CITY OF PROVIDENCE, RHODE ISLAND

RFP Title: SPLASHPAD IMPROVEMENTS AT JOSLIN PARK

Addendum #: 2

SPLASHPAD IMPROVEMENTS AT JOSLIN PARK

Site Layout

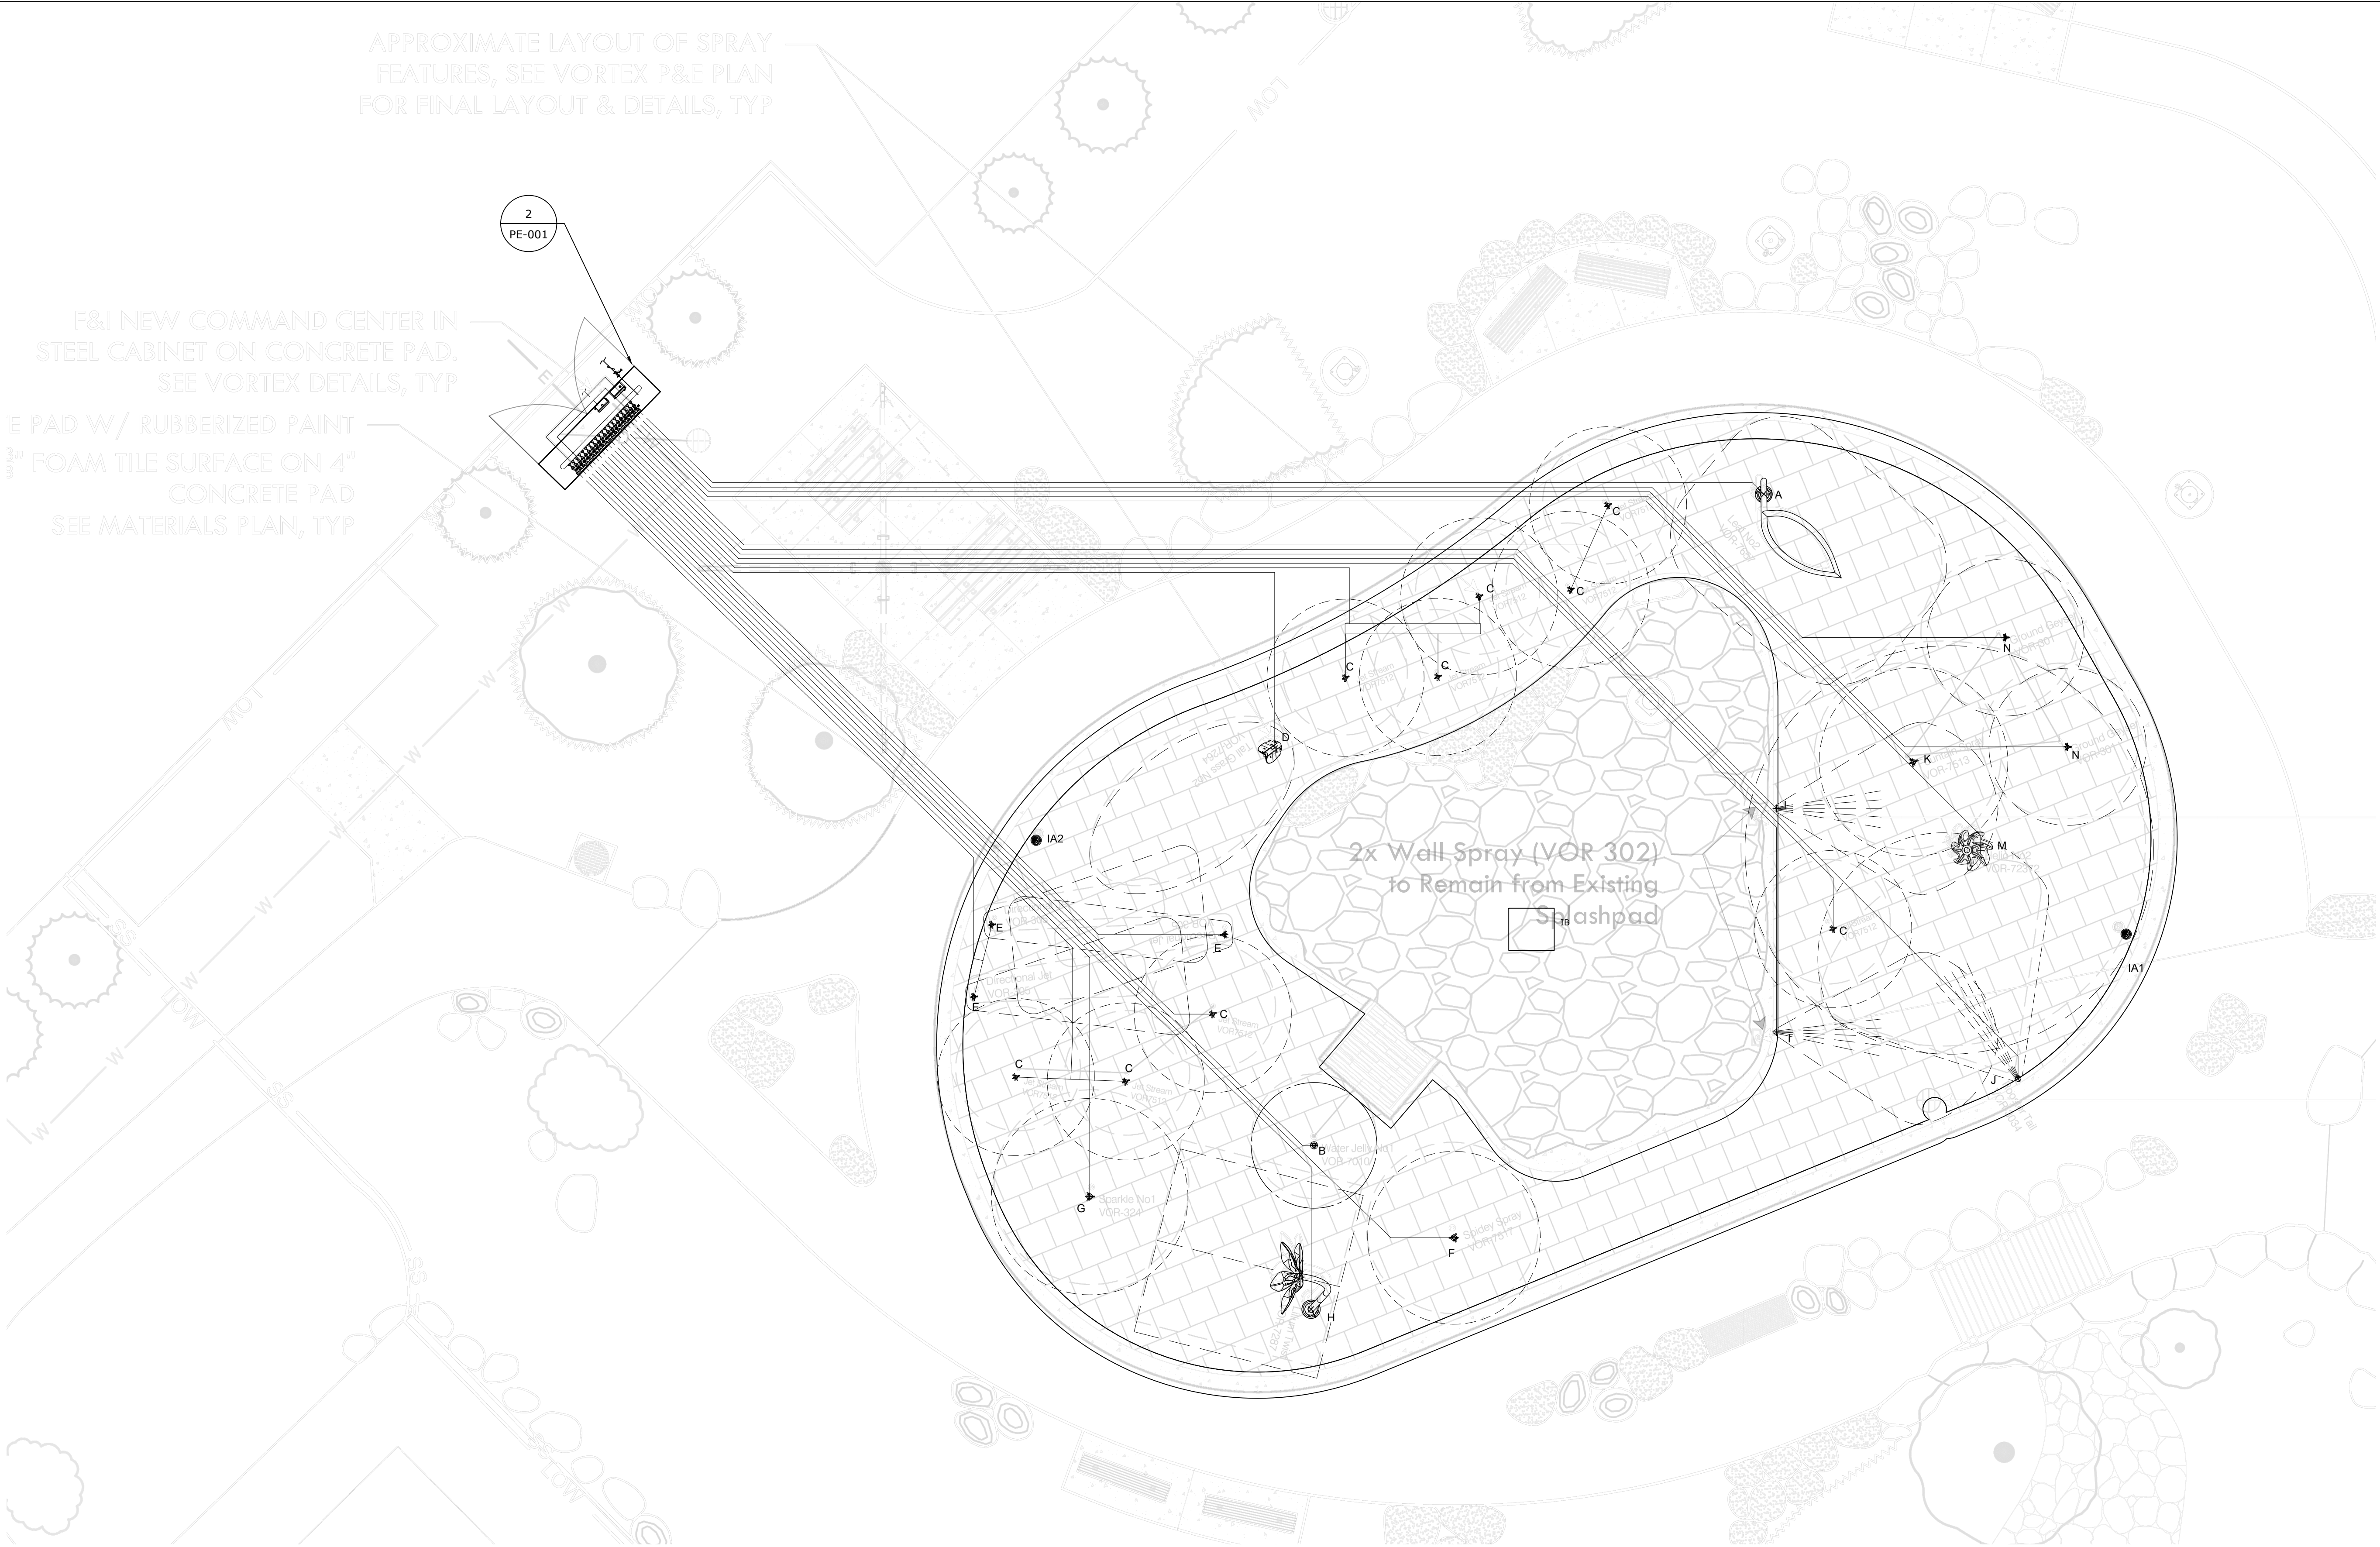
1. Vortex P&E Plan attached, note that command center cabinet is larger than shown on Parks Plans, so concrete pad will have to be larger, (3'-2" x 9'-10" detail attached)
2. Q: Will the Aqua Tile be in the same pattern as the Base Bid Paint?
A: No, the tile will be in an offset grid pattern using 3-colors, the tiles will only need to be trimmed at the edges.
3. Q: Is there a product specified for the paint?
A: The Basis-of-Design product is Benjamin Moore INSL-X Chlorinated Rubber Swimming Pool Paint, but any equal chlorinated rubber pool paint is acceptable.
4. On Page 6 of the RFP, where it asks for *Total Amount* of Bid, please include the allowance.
5. Items #38 and #40 in the Base Bid Unit Prices (page 19) are not in the project, these can be crossed out on the bid form.
